PLANNING & ZONING COMMISSION MEETING HARKER HEIGHTS CITY HALL WEDNESDAY, SEPTEMEBER 29, 2021 – 5:30 P.M.

- 1. P21-26 Discuss and consider a request for a preliminary plat referred to as Stillhouse Road Addition on property described as R.W. Tom survey, abstract No. 837, and the Lucy O'Dell Survey, Abstract No. 644, and the land herein described being all of that certain called 1.50 acre tract of land conveyed to Star Stillhouse Properties, LLC, a Texas Limited Liability Company, by Correction Special Warranty Deed with Vendor's Lien recorded in Document 2021000947, Official Public Records of Bell County, Texas, generally located on the east side of Stillhouse Lake Road and north of Nevaeh Road, Harker Heights, Bell County, Texas.

- 2. P21-27 Discuss and consider a request for a preliminary plat referred to as Chaparral Road Addition on property described as Peter Williamson Survey, Abstract No. 1099 and the land herein described being a portion of that certain 3.79 acre tract conveyed to Rena Chang Hoot by Gift Deed recorded in Volume 3475, Page 616, Official Public Records of Bell County, Texas, generally located at the intersection of Chaparral Road and F.M. 3481 (Stillhouse La

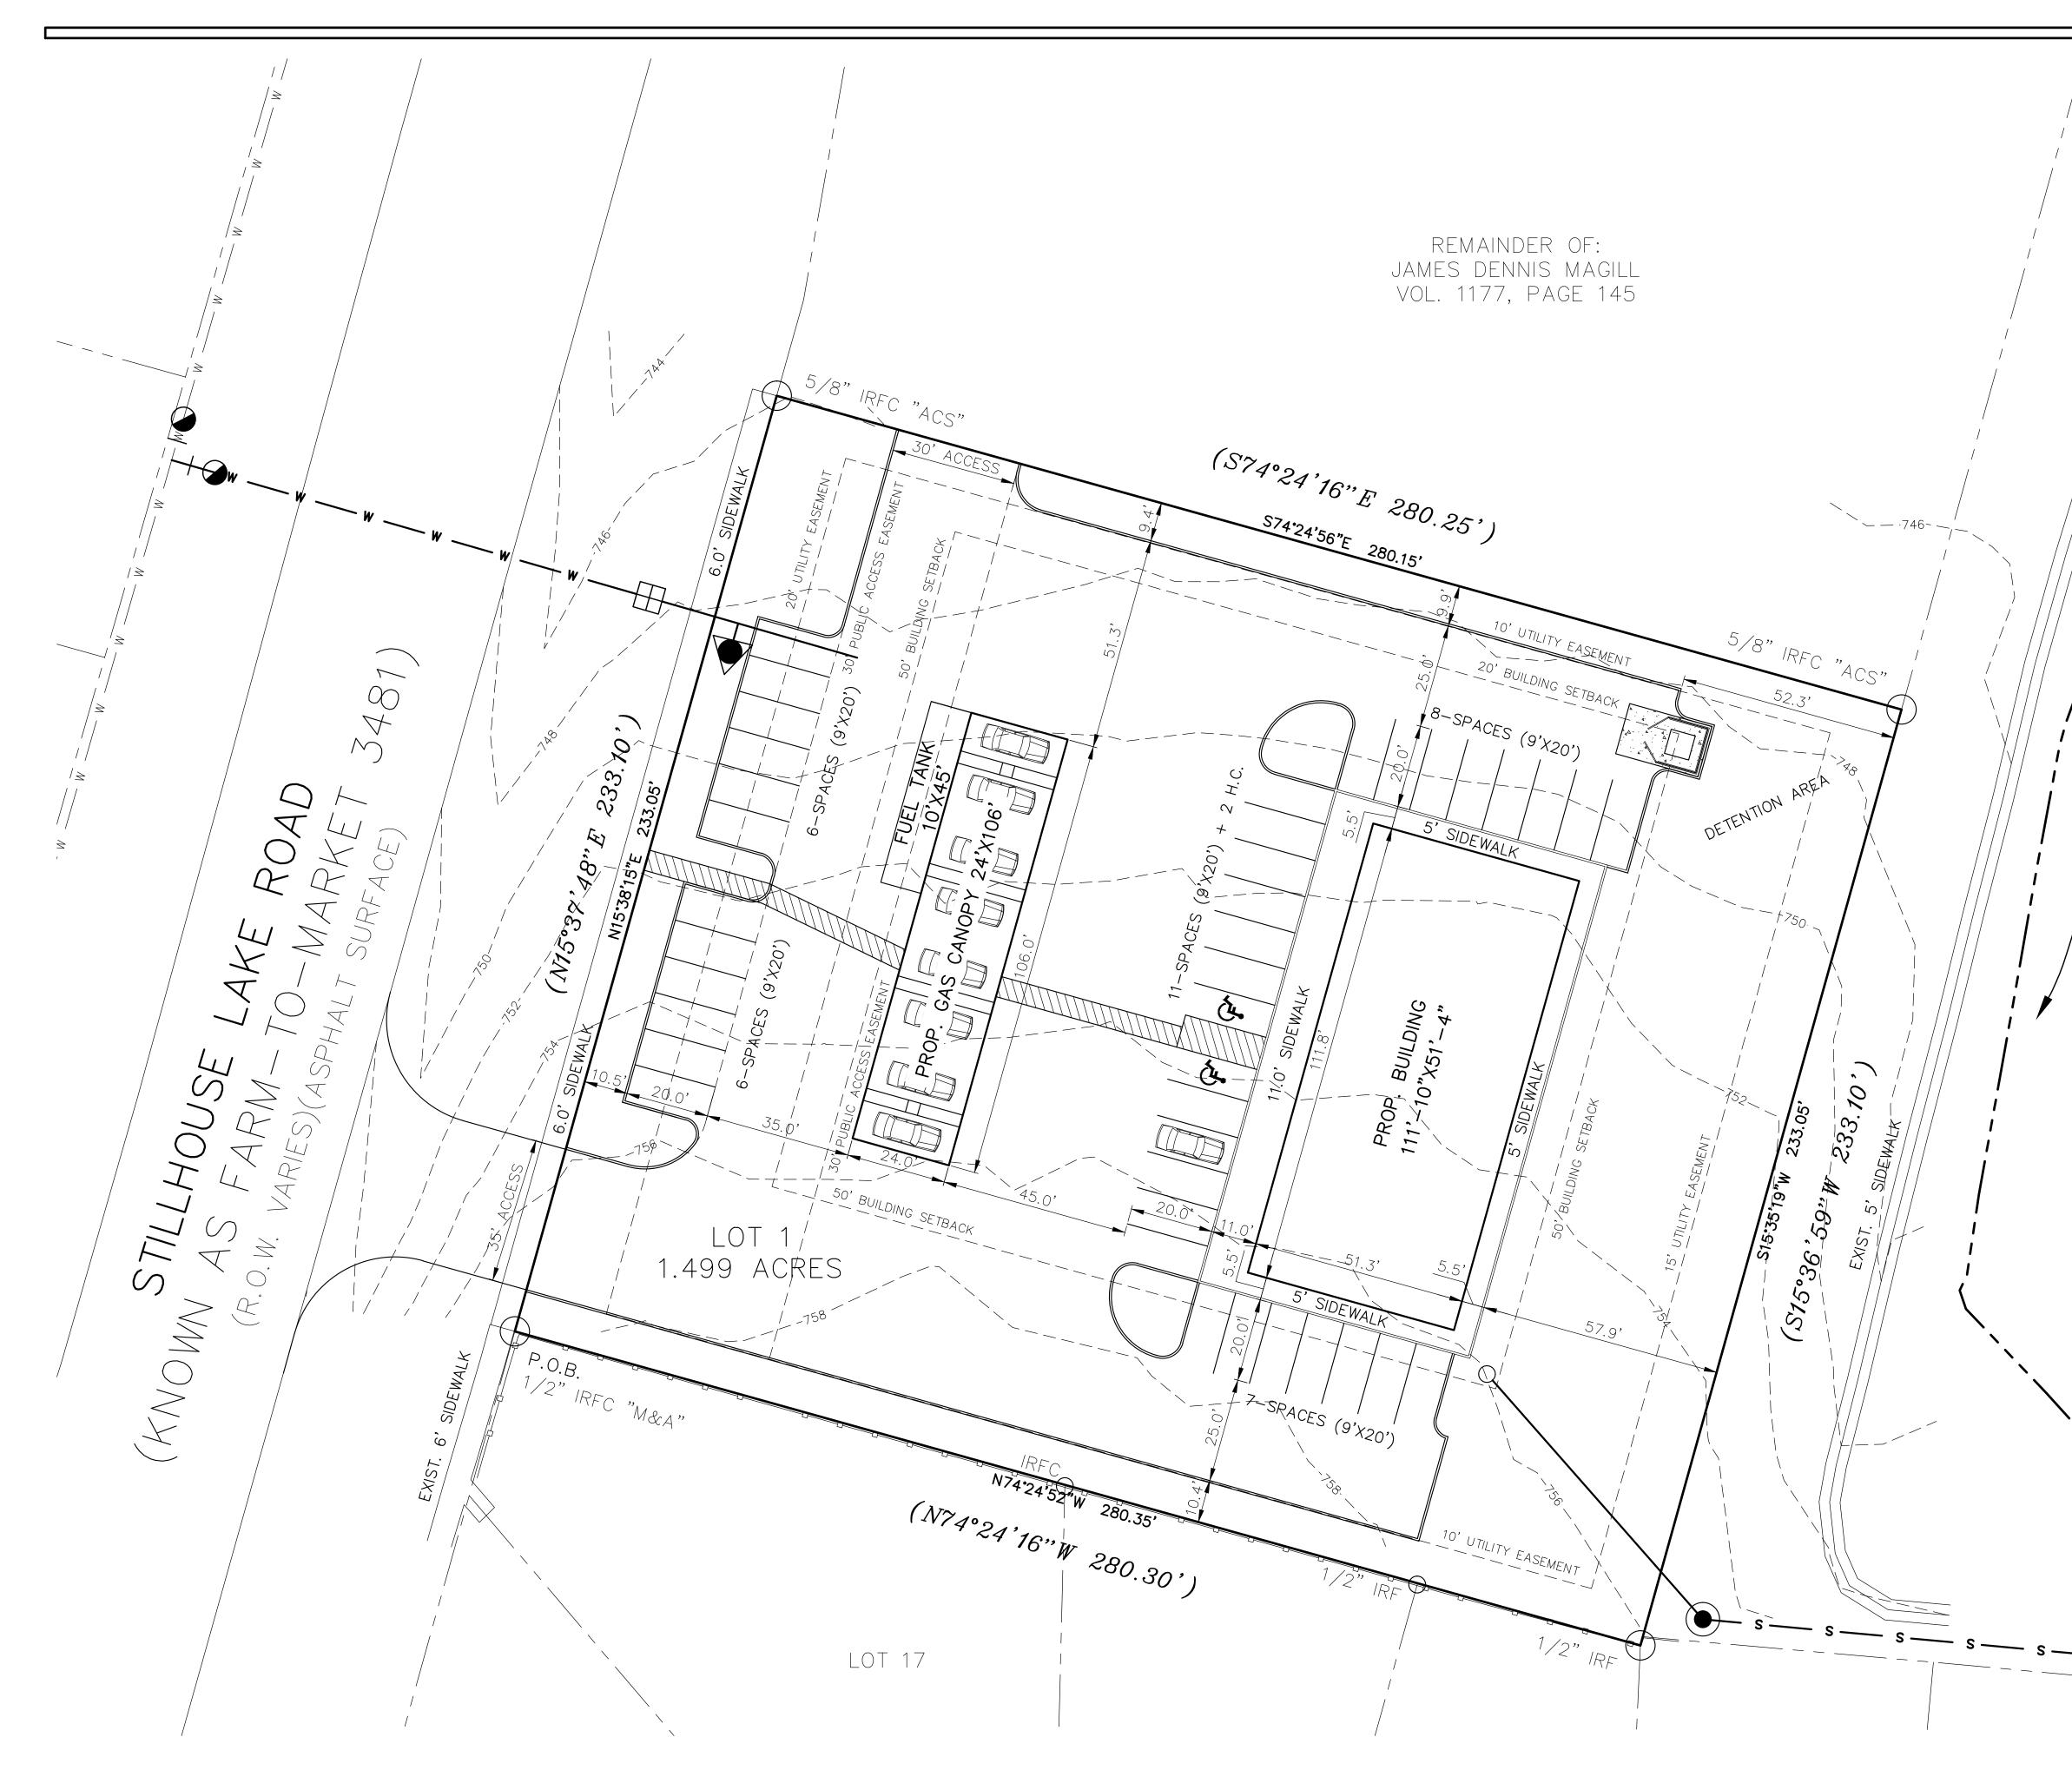
- 1. Applicant shall revise the field notes, dedication document, and plat dedication page such that the legal property descriptions match.
- 2. Plat Dedication Page: Applicant shall provide LLC paperwork and provide authorization for those who can sign for Star Stillhouse Properties LLC.

- 3. Plat Dedication Page: Applicant shall provide a plat dedication page and dedication document executed by the owner.
- 4. Plat Dedication Page: Applicant shall annotate the called 30' access as a 30' public access easement.

- Plat Dedication Page: Applicant shall provide dimensions (distances, direction, curves, etc.) for the 30' public access easement such that the location can be determined in the field, or provide & reference a separate instrument for said easements.

- 6. Per §154.21(C)(1)(j), applicant shall provide a draft of the offsite utility easement for the sewer line through the property to the east of this parcel. Applicant is advised that said easement must be executed and recorded prior to release of public utility construction plans for this parcel and prior to final plat.

- 7. Per §154.21(C)(1)(j), applicant shall extend utility easement(s) for water & sewer to the adjoining called 2.15 acre lot to the north of the parcel being platted or show how access is currently available to said parcel. Said utility easement(s) shall not be in conflict with the proposed drainage structure.

- 9. Per §154.21(C)(2)(d), applicant shall provide a sidewalk layout. Additionally, said sidewalk shall be in accordance with the City's Mobility 2030 plan (6'-10' wide for this area).

- 1. Applicant shall revise the field notes, dedication document, and plat dedication page such that the legal property descriptions match. The field notes, dedication instrument and plat dedication match.

- Plat Dedication Page: Applicant shall provide LLC paperwork and provide authorization for those who can sign for Star Stillhouse Properties LLC. Owner is in the process of gaining information regarding authorization. Paperwork will be provided when received.

- 3. Plat Dedication Page: Applicant shall provide a plat dedication page and dedication document executed by the owner. Noted
- 4. Plat Dedication Page: Applicant shall annotate the called 30' access as a 30' public access easement. 30' access easement called 30' public access easement.

- 5. Plat Dedication Page: Applicant shall provide dimensions (distances, direction, curves, etc.) for the 30' public access easement such that the location can be determined in the field, or provide & reference a separate instrument for said easements. Bearings, distances and labels added to 30' public access easement for field determination.

- 6. Per §154.21(C)(1)(j), applicant shall provide a draft of the offsite utility easement for the sewer line through the property to the east of this parcel. Applicant is advised that said easement must be executed and recorded prior to release of public utility construction plans for this parcel and prior to final plat. Draft of offsite utility easement for sewer line through parcel to the east will be provided once the review team accepts the proposed schematic for sewer line extension.

- 7. Per §154.21(C)(1)(j), applicant shall extend utility easement(s) for water & sewer to the adjoining called 2.15 acre lot to the north of the parcel being platted or show how access is currently available to said parcel. Said utility easement(s) shall not be in conflict with the proposed drainage structure. 20' utility easement offset from western boundary and 15' utility easement offset from eastern boundary for 2.15 acre tract to the north.

- 9. Per §154.21(C)(2)(d), applicant shall provide a sidewalk layout. Additionally, said sidewalk shall be in accordance with the City's Mobility 2030 plan (6'-10' wide for this area). 6' sidewalk added to boundary line bordering Stillhouse Lake Road. Proposed 6' sidewalk shown on the Stillhouse Gas Station concept layout.

- Applicant shall revise the field notes, dedication document, and plat dedication page such that the legal property descriptions match. 9/22/21 Applicant's response is noted. Applicant shall clarify the differences between the documents and within the Field Notes with respect to the acreage of the parcel begin platted (1.499 acres vs 1.50 acres). We acknowledge this is a small deviation but want to be sure that the correct public notice is given.

- Plat Dedication Page: Applicant shall provide LLC paperwork and provide authorization for those who can sign for Star Stillhouse Properties LLC. 9/22/21 Applicant's response is noted. Staff can not recommend approval until this information is provided.

- Plat Dedication Page: Applicant shall provide a plat dedication page and dedication document executed by the owner. 9/22/21 Applicant's response is noted. Staff can not recommend approval until this information is provided.

- 4. Plat Dedication Page: Applicant shall annotate the called 30' access as a 30' public access easement. 9/22/21 Met.
- Plat Dedication Page: Applicant shall provide dimensions (distances, direction, curves, etc.) for the 30' public access easement such that the location can be determined in the field, or provide & reference a separate instrument for said easements. 9/22/21 Met.

- 6. Per §154.21(C)(1)(j), applicant shall provide a draft of the offsite utility easement for the sewer line through the property to the east of this parcel. Applicant is advised that said easement must be executed and recorded prior to release of public utility construction plans for this parcel and prior to final plat. 9/22/21 Applicant's response is noted. Staff can not recommend approval until this information is provided.

- 7. Per §154.21(C)(1)(j), applicant shall extend utility easement(s) for water & sewer to the adjoining called 2.15 acre lot to the north of the parcel being platted or show how access is currently available to said parcel. Said utility easement(s) shall not be in conflict with the proposed drainage structure. 9/22/21 Met.

- Per §154.21(C)(2)(d), applicant shall provide a sidewalk layout. Additionally, said sidewalk shall be in accordance with the City's Mobility 2030 plan (6'-10' wide for this area). 9/22/21 Met.

CONCEPT PLAN FOR: **STILLHOUSE GAS STATION** CITY OF HARKER HEIGHTS, BELL COUNTY, TEXAS WATER LAYOUT STANDARD NOTES:

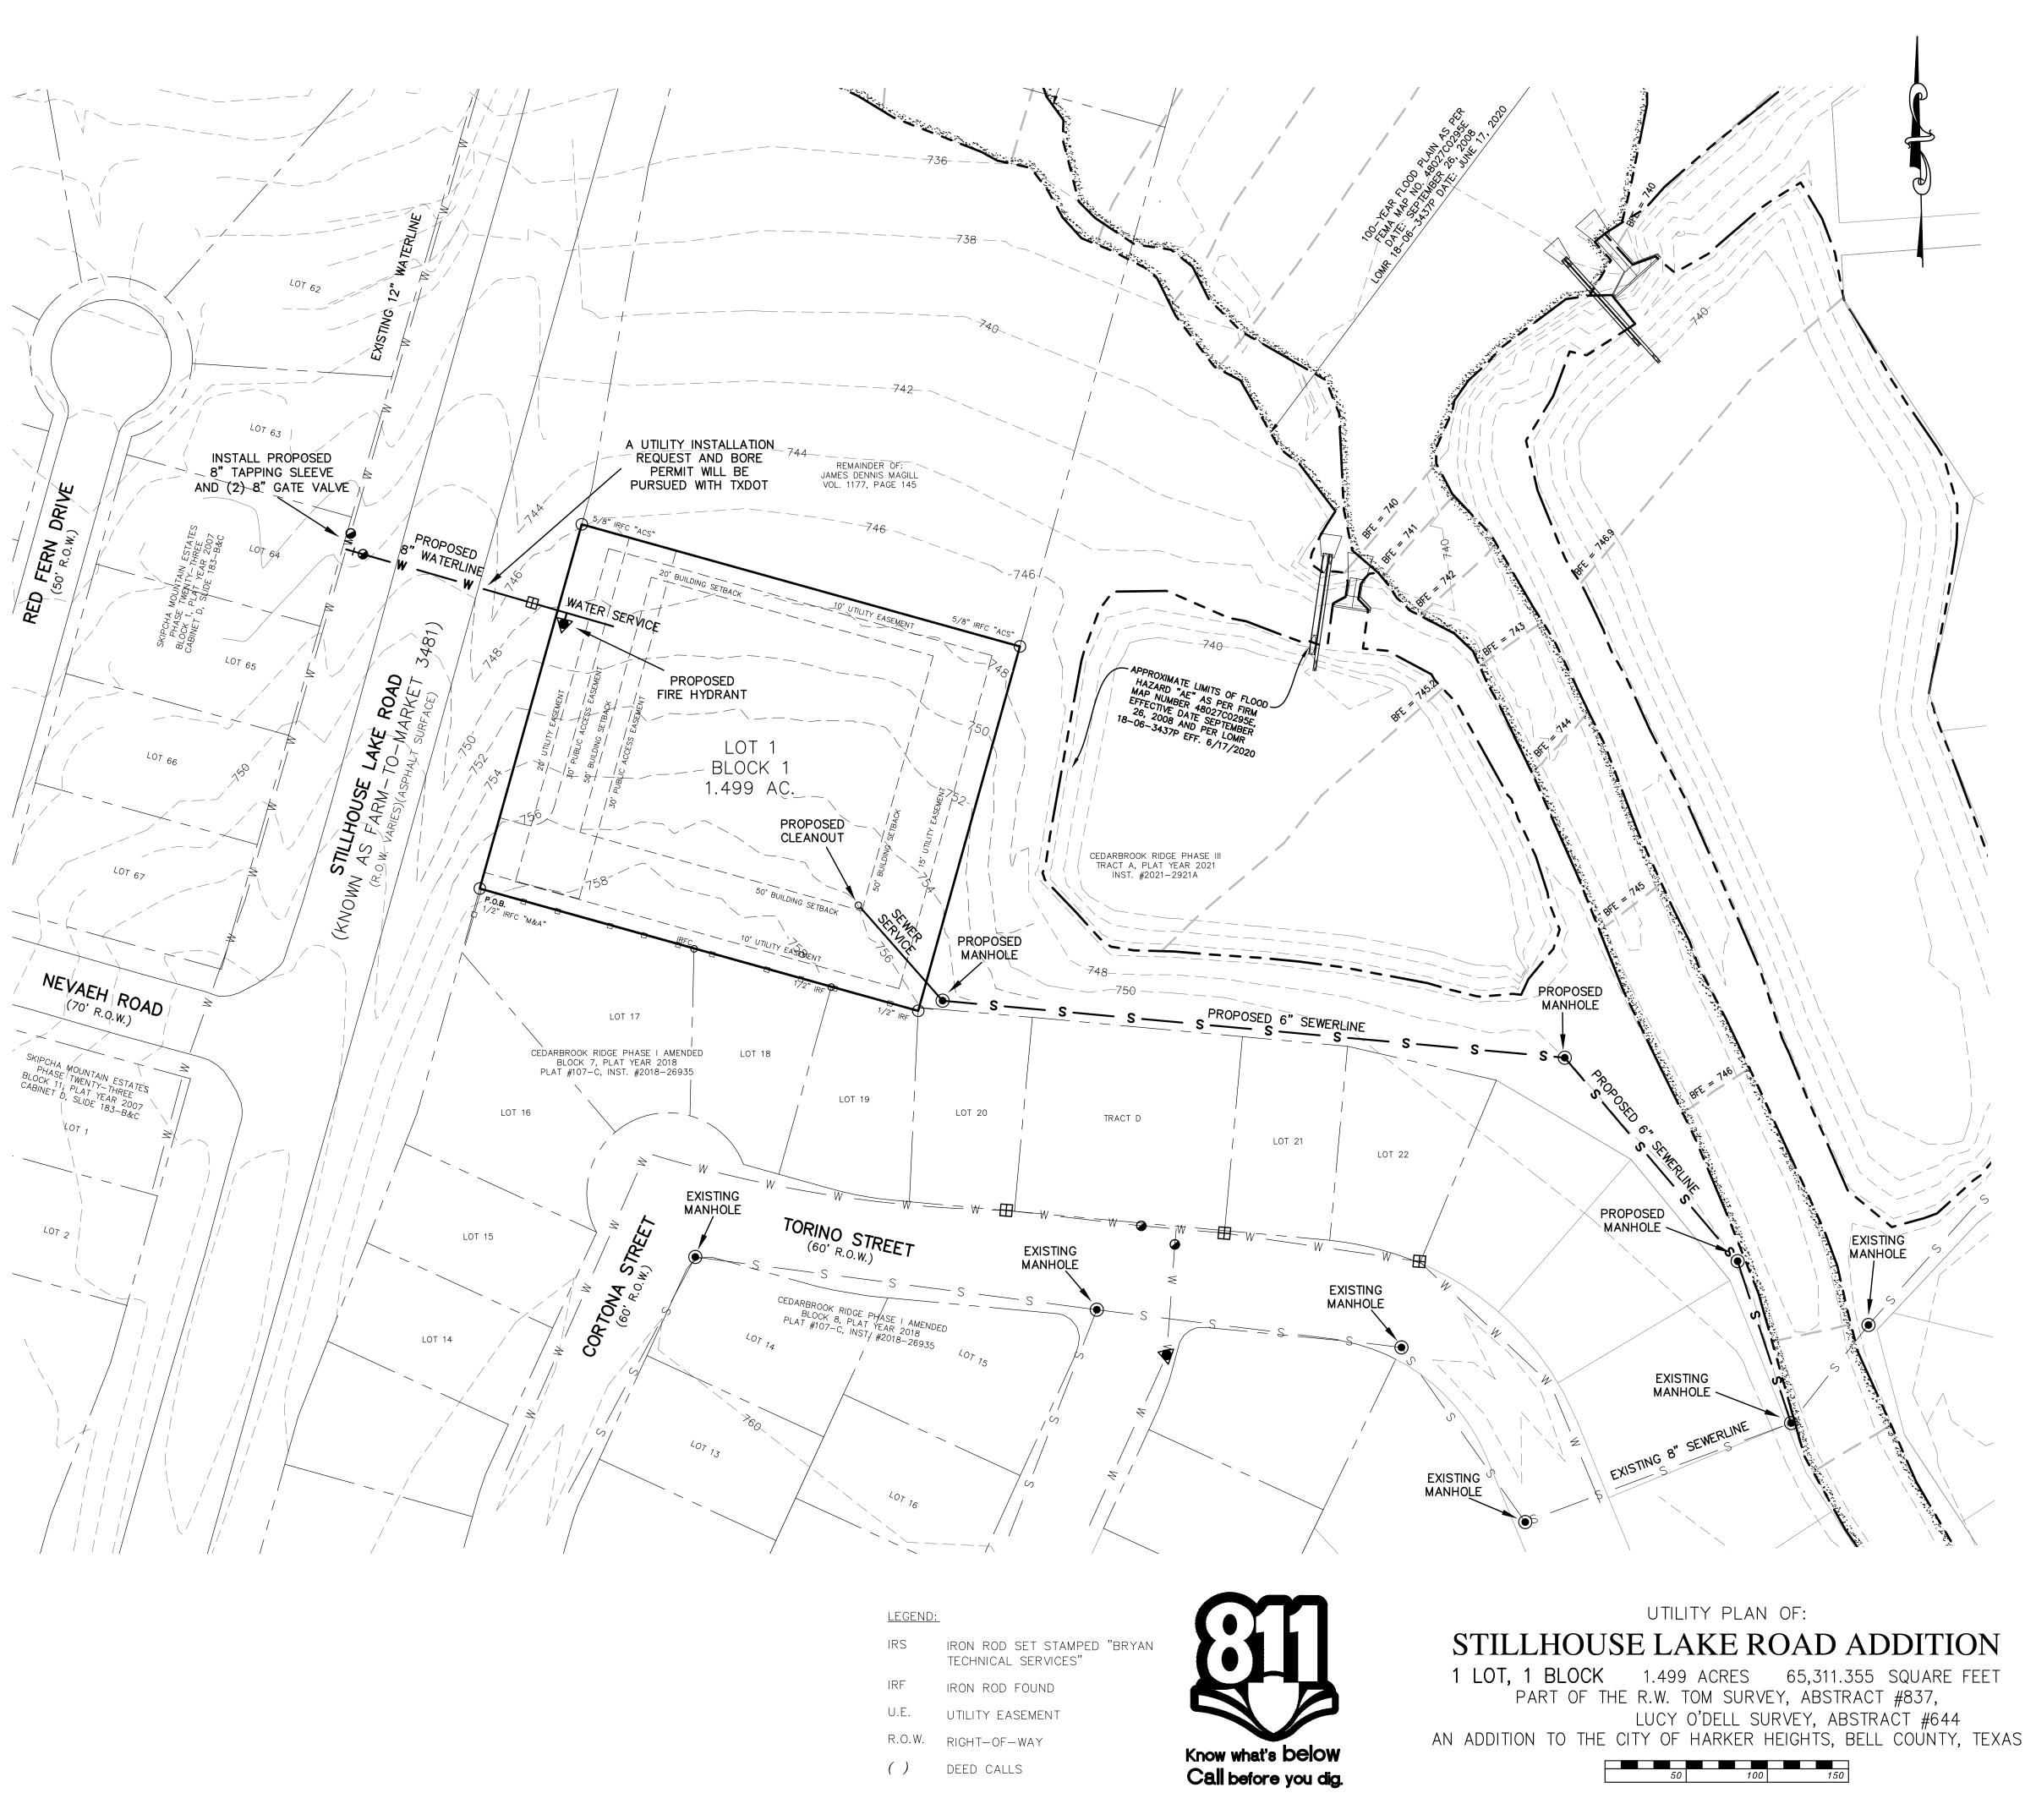
The proposed water line shown on the utility layout is 8-inches in diameter. The tap on the 12-inch water line is called out as a 6-inch tap with tapping sleeve and two 6-inch gate valves. Change the annotation to 8-inch tapping sleeve and valve. FM 3481 is a TxDOT facility, a bore permit will be required along with a plan & profile drawing of the proposed bore.

1. Page C1-Site concept plan does not address all Building, Fire, City Ordinance or Overlay district requirements. Any issues must be addressed during construction plan set review.

- 1. Add a 20ft utility easement on the West property boundary.
- 2. Add a 10ft utility easement on the North, South, East property boundaries.

The proposed water line shown on the utility layout is 8-inches in diameter. The tap on the 12-inch water line is called out as a 6-inch tap with tapping sleeve and two 6-inch gate valves. Change the annotation to 8-inch tapping sleeve and valve. FM 3481 is a TxDOT facility, a bore permit will be required along with a plan & profile drawing of the proposed bore. Tapping sleeve and two gate valves called out to be 8" on C2.0. A bore permit/utility installation request will be pursued with TxDOT during construction phase.

1. Page C1-Site concept plan does not address all Building, Fire, City Ordinance or Overlay district requirements. Any issues must be addressed during construction plan set review. Noted

- 1. Add a 20ft utility easement on the West property boundary. 20' U.E. added to the west property boundary line.
- 2. Add a 10ft utility easement on the North, South, East property boundaries. 10' U.E. added to the north and south property lines, and 15' U.E. added to the east line.

The proposed water line shown on the utility layout is 8-inches in diameter. The tap on the 12-inch water line is called out as a 6-inch tap with tapping sleeve and two 6-inch gate valves. Change the annotation to 8-inch tapping sleeve and valve. FM 3481 is a TxDOT facility, a bore permit will be required along with a plan & profile drawing of the proposed bore. 9/22/21 Met.

- 1. Add a 20ft utility easement on the West property boundary. 9/22/21 Met.
- 2. Add a 10ft utility easement on the North, South, East property boundaries. 9/22/21 Met.
